Waitakere City Council Feedback and Comments on: NRC Concept Design Report For NAL Stage 2 Duplication (New Lynn to Henderson) October 2004.

Proposed Rail Corridor Cycleway – New Lynn to Henderson

Waitakere Central – Henderson Interchange
Developed Design Sign Off

To	Kevin Wright
From	Warren Cornor
Date	23 December 2004
Subject	Henderson Interchange

NOVEMBER 2004 | Prepared for **WAITAKERE CITY COUNCIL** | Drawing **AIRBRIDGE PLAN** | Scale 1:200 @ A3 | Drawing no **SD-03** | Issue **A**

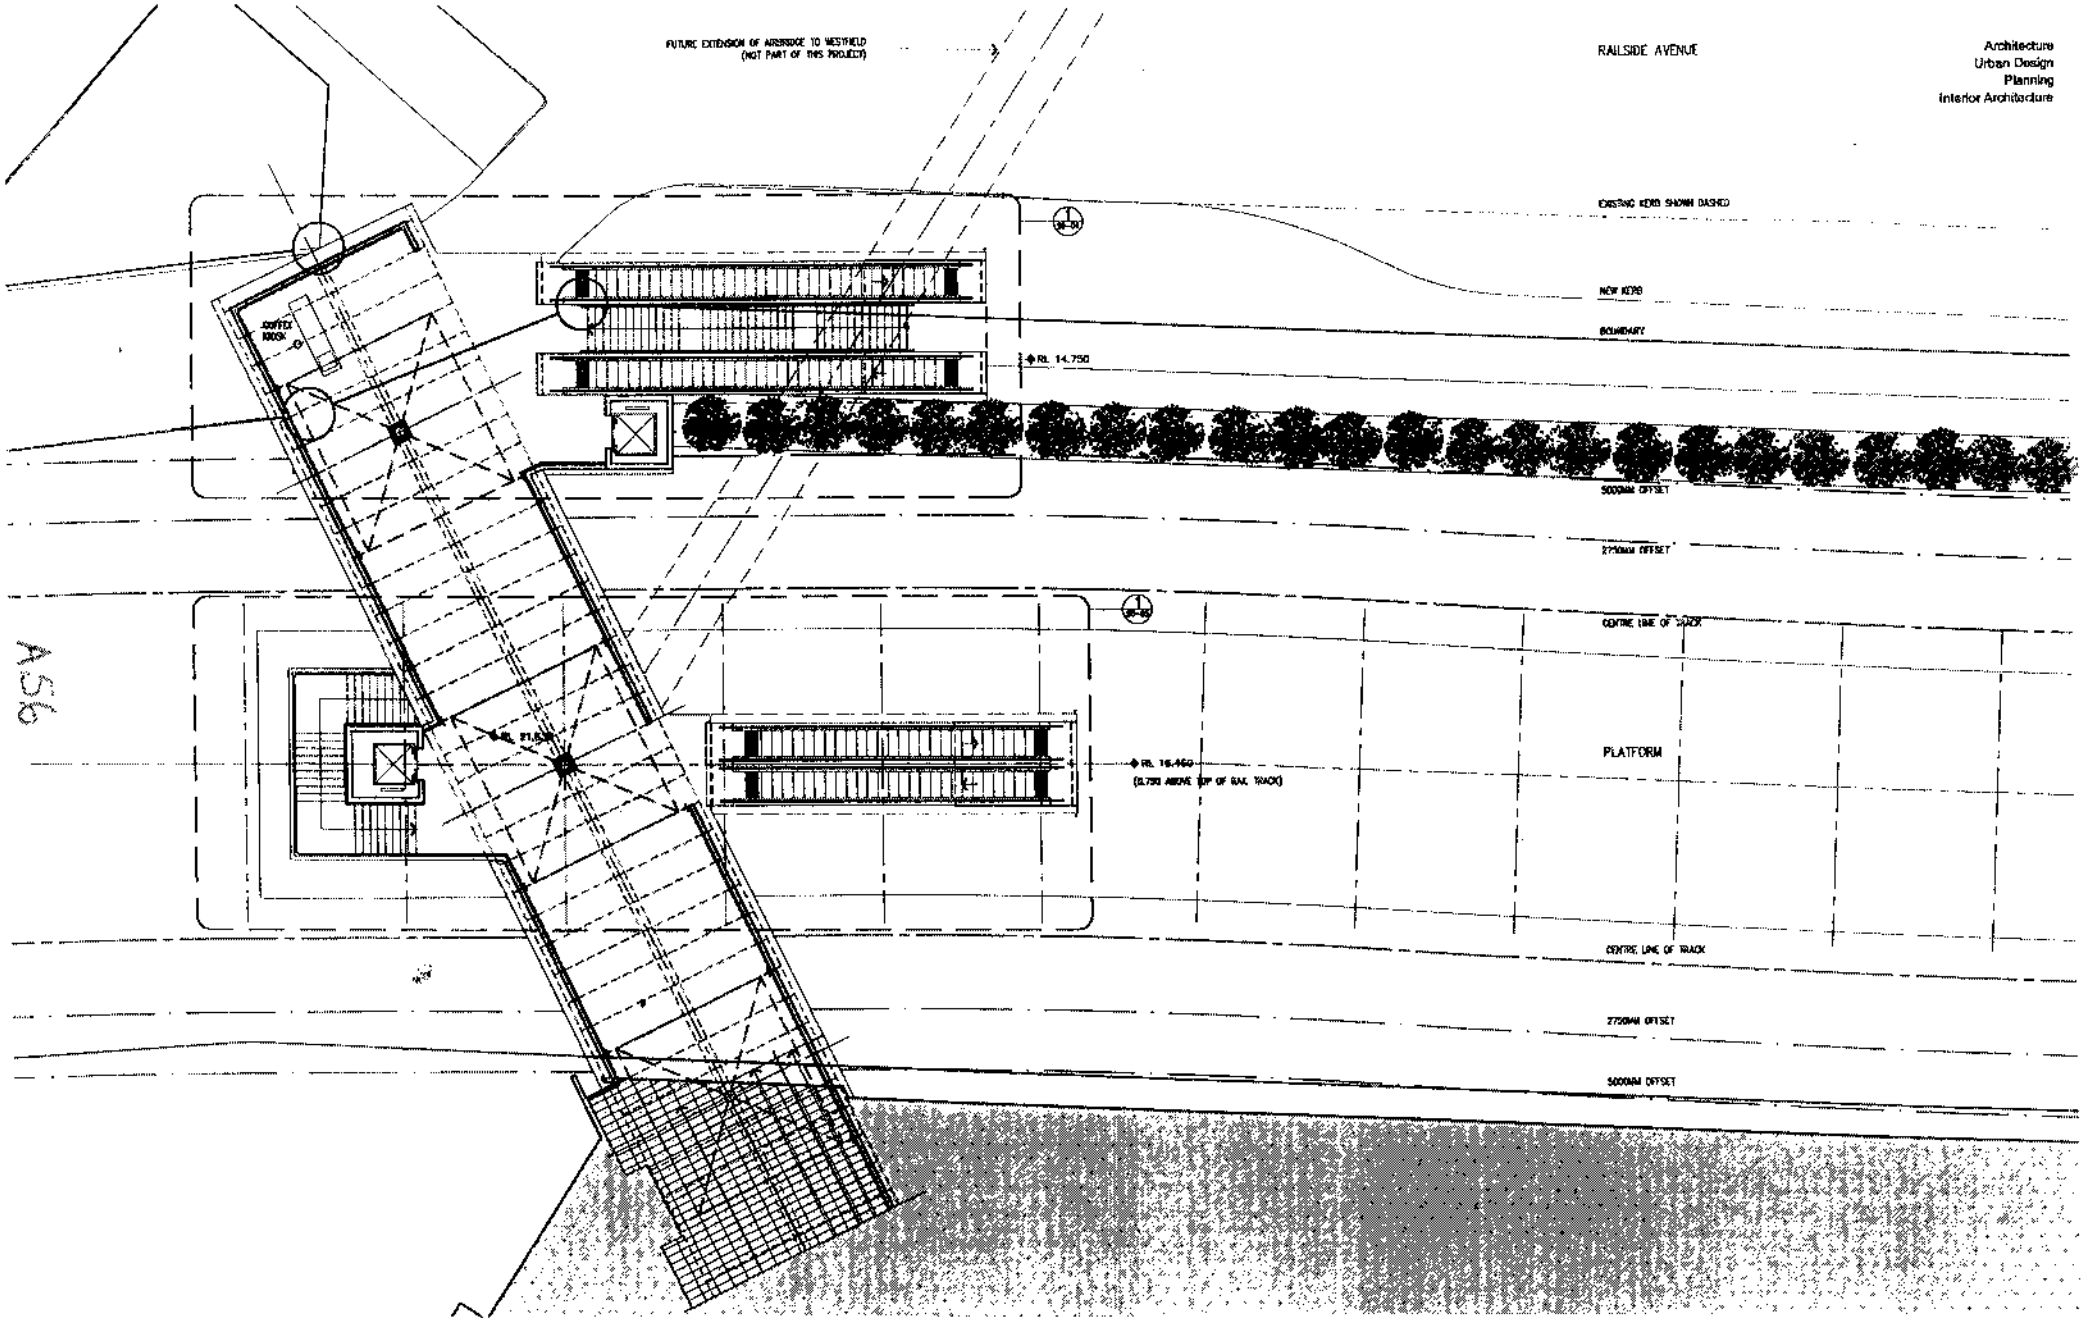
- SD-03 future link to Westfield – confirm that it is it high enough above escalators to not cause problems. Is it possible to link at the end of the airbridge to ensure that any future extension does not require work over the rail corridor.
